SS 581860 FCCC 15 Gallon DEF Header Service Replacement Additional Parts (299)

Original SSI DEF Header, which has been discontinued, has failed and needs to be replaced. Replacement KUS DEF header must be used as replacement, but MAY require additional parts and re-routing of DEF Coolant lines and DEF lines to the new KUS DEF header 04-37616-000.

SSI TO KUS COMPARSION (15GAL DEF SYSTEM)

TYPE 10

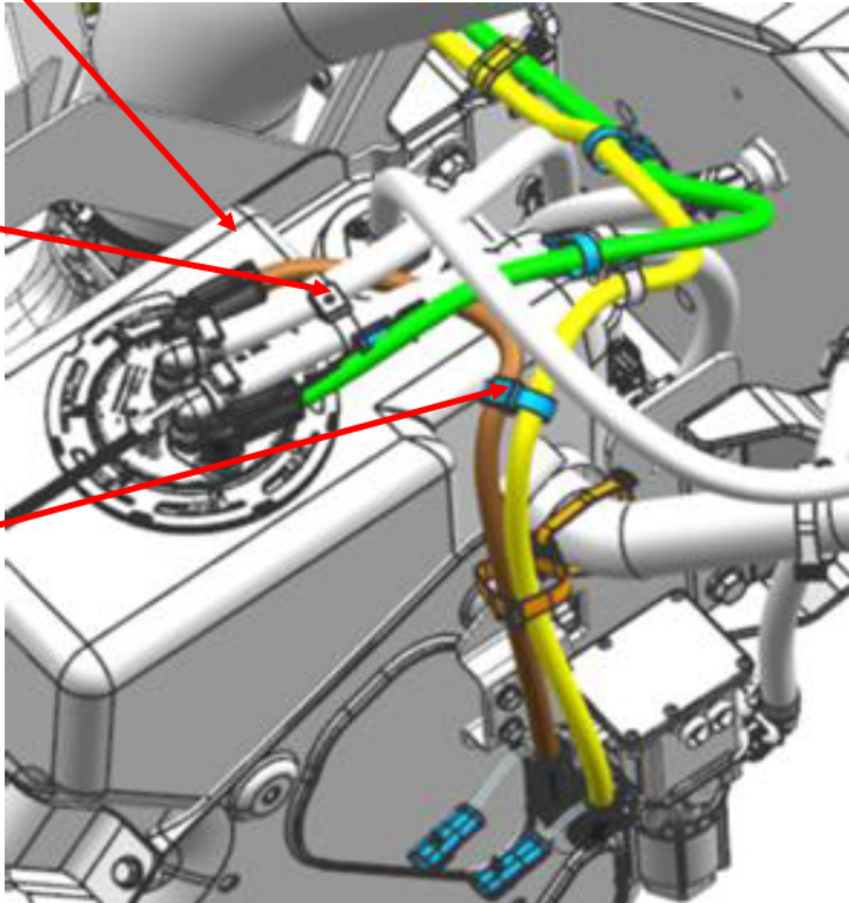
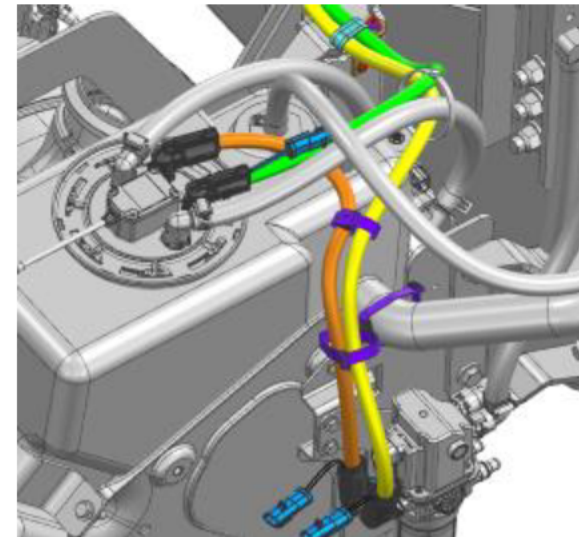
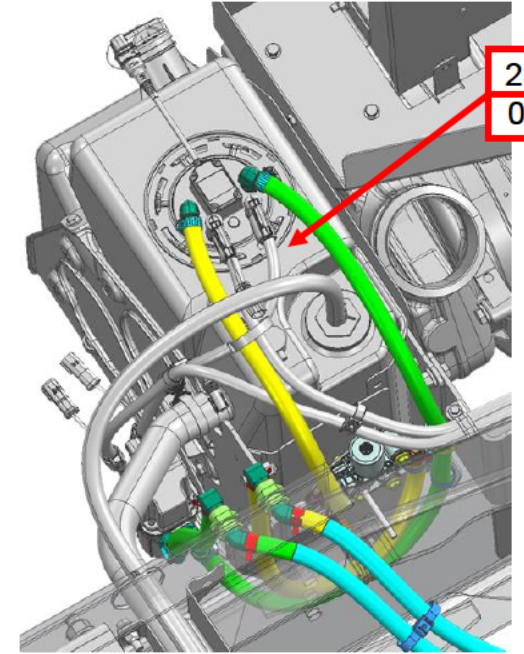
Required parts to KUS

DEF SYSTEM		SSI			KUS		
MOD	DESCRIPTION	ITEM NUMBER	ITEM	QTY	ITEM NUMBER	ITEM	QTY
23U	BILL	-	23U-C06227	-	-	23U-C06247	-
	PARTS	001	A04-36022-000	1	001	A04-37438-000	1
23V	BILL	-	23V-C05532	-	-	23V-C05569	-
	INSTALL	-	D04-35709-000	-	-	D04-37531-000	-
	PARTS	007	TYCDCT110HIR	1	-	-	-
23W	BILL	-	23W-C00398	-	-	23W-C14109	-
	INSTALL	-	D04-36922-000	-	-	D04-37555-000	-
	PARTS	005	TYCDCT110HIR	1	-	-	-

TYPE 11

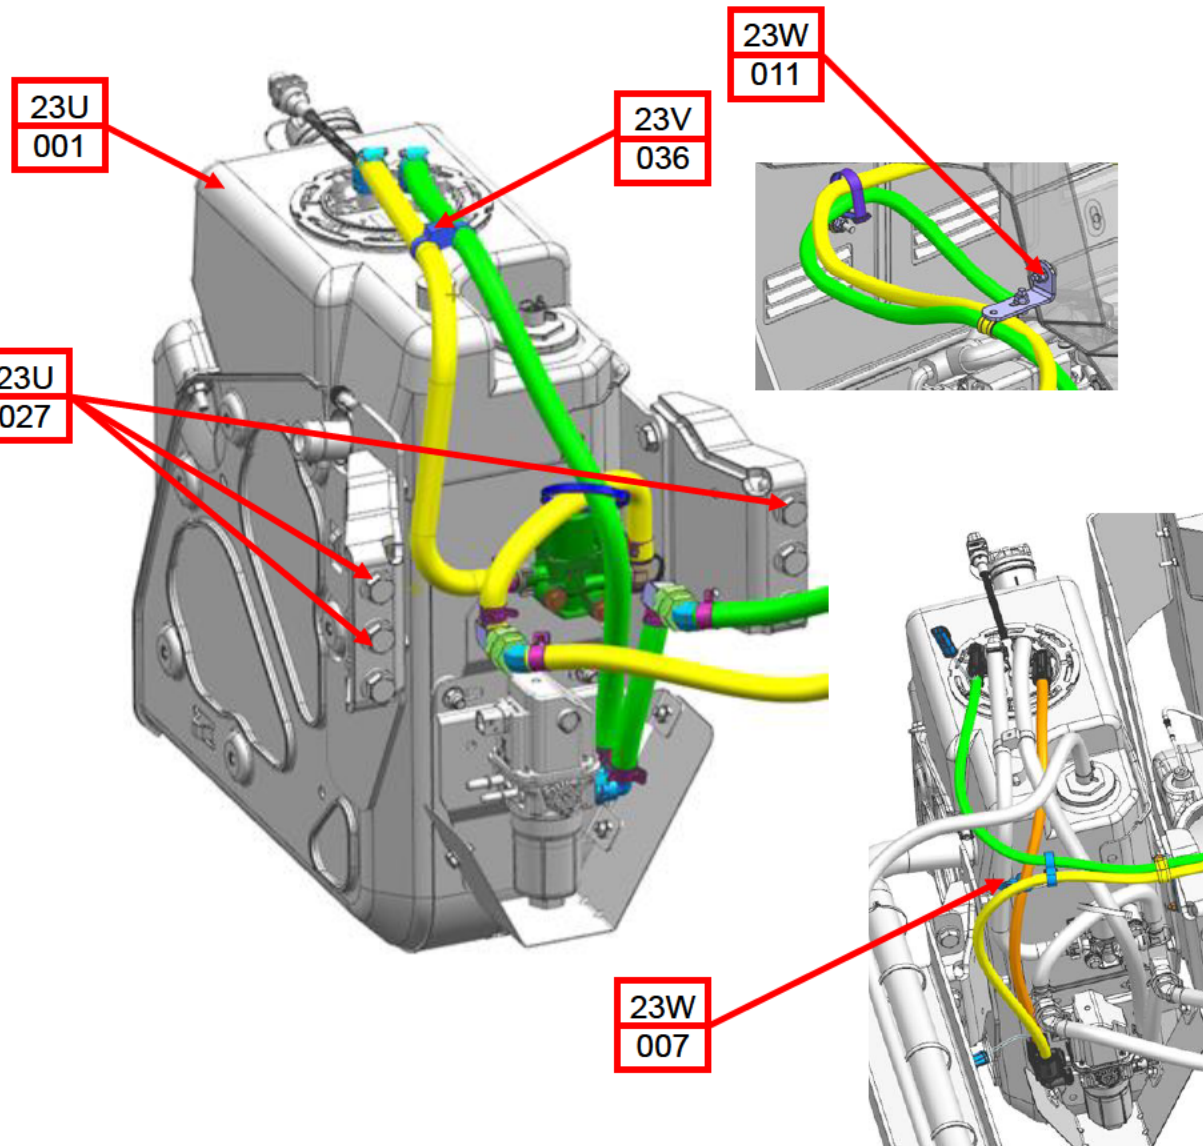
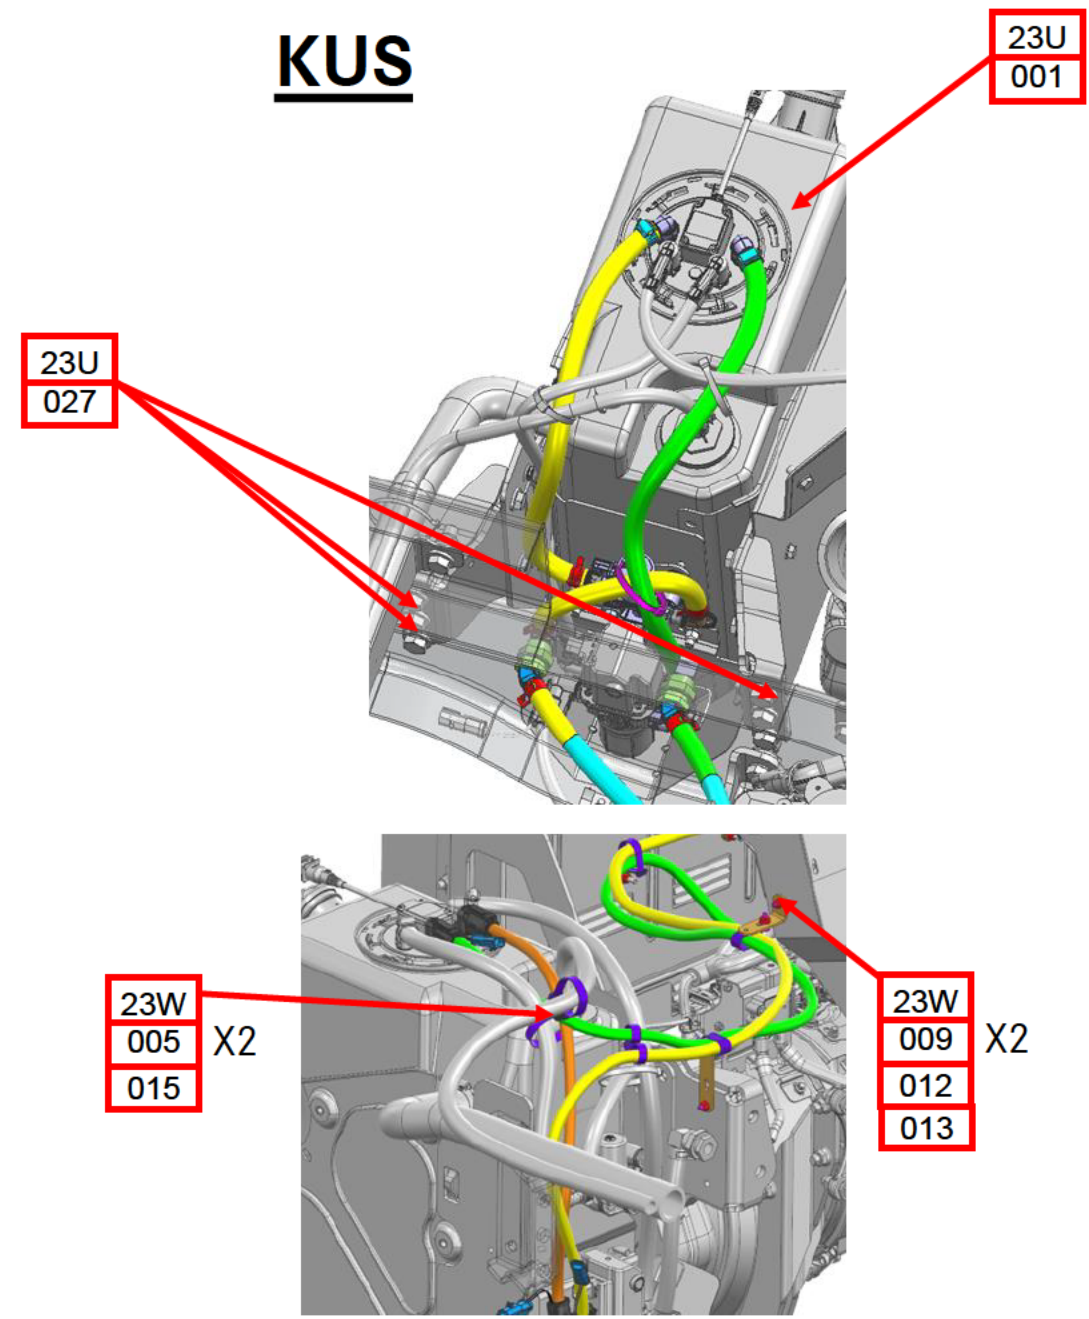
Required parts to KUS

DEF SYSTEM		SSI			KUS		
MOD	DESCRIPTION	ITEM NUMBER	ITEM	QTY	ITEM NUMBER	ITEM	QTY
23U	BILL	-	23U-C06230	-	-	23U-C06248	-
	PARTS	001	A04-36022-000	1	001	A04-37438-000	1
		027	23-11755-175	3	027	23-11755-225	3
23V	BILL	-	23V-C05538	-	-	23V-C05570	-
	INSTALL	-	D04-35710-000	-	-	D04-37532-000	-
	PARTS	036	TYCDCT110HIR	1	-	-	-
23W	BILL	-	23W-C13300	-	-	23W-C14125	-
	INSTALL	-	D04-37266-000	-	-	D04-37691-000	-
	PARTS	007	TYCDCT110HIR	1	015	23-12886-001	1
		011	23-10742-100	1	009	23-10742-075	2
		-	-	-	013	23-10900-025	1
		-	-	-	005	23-13476-000	2
		-	-	-	012	23-13861-104	1

TYPE 12

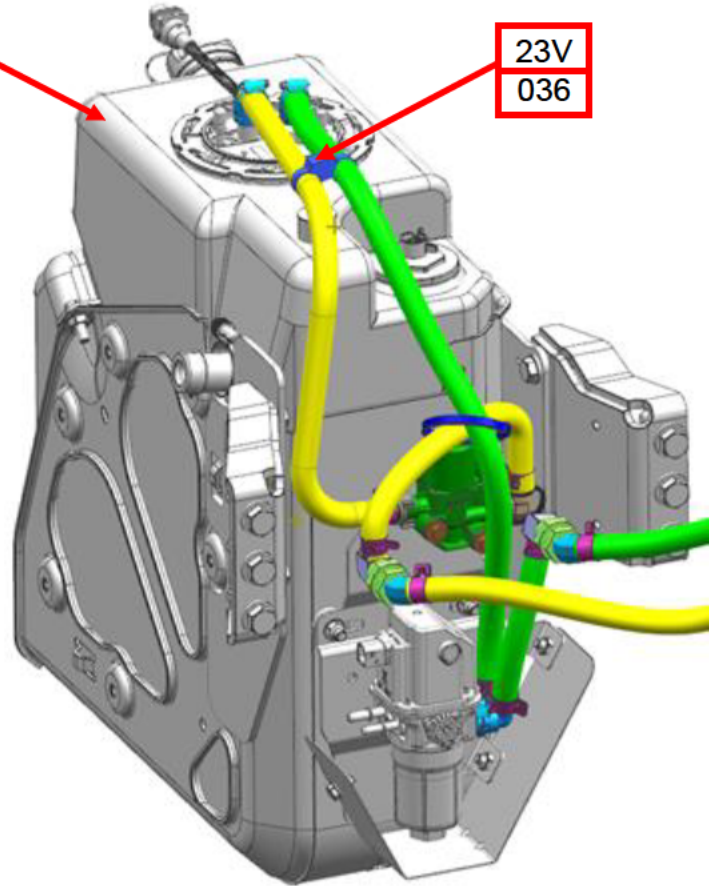
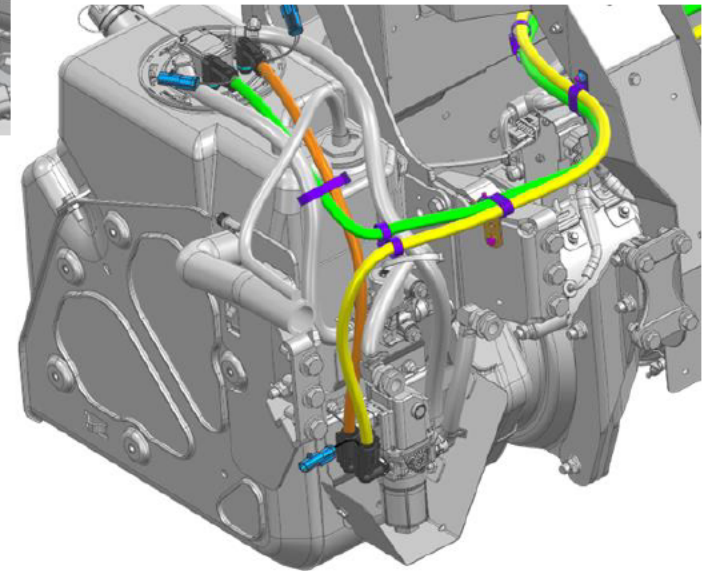
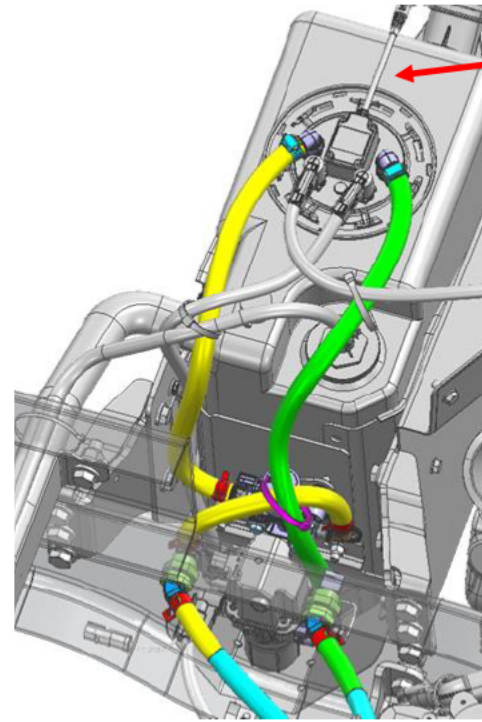
Required parts to KUS

DEF SYSTEM		SSI			KUS		
MOD	DESCRIPTION	ITEM NUMBER	ITEM	QTY	ITEM NUMBER	ITEM	QTY
23U	BILL	-	23U-C06240	-	-	23U-C06261	-
	PARTS	001	A04-36022-000	1	001	A04-37438-000	1
23V	BILL	-	23V-C05538	-	-	23V-C05570	-
	INSTALL	-	D04-35710-000	-	-	D04-37532-000	-
	PARTS	036	TYCDCT110HIR	1	-	-	-
23W	BILL	-	23W-C13301	-	-	23W-C14126	-
	INSTALL	-	D04-37470-000	-	-	D04-37692-000	-
	PARTS	009	23-10742-075	2	-	-	-
		005	23-13476-000	2	-	-	-
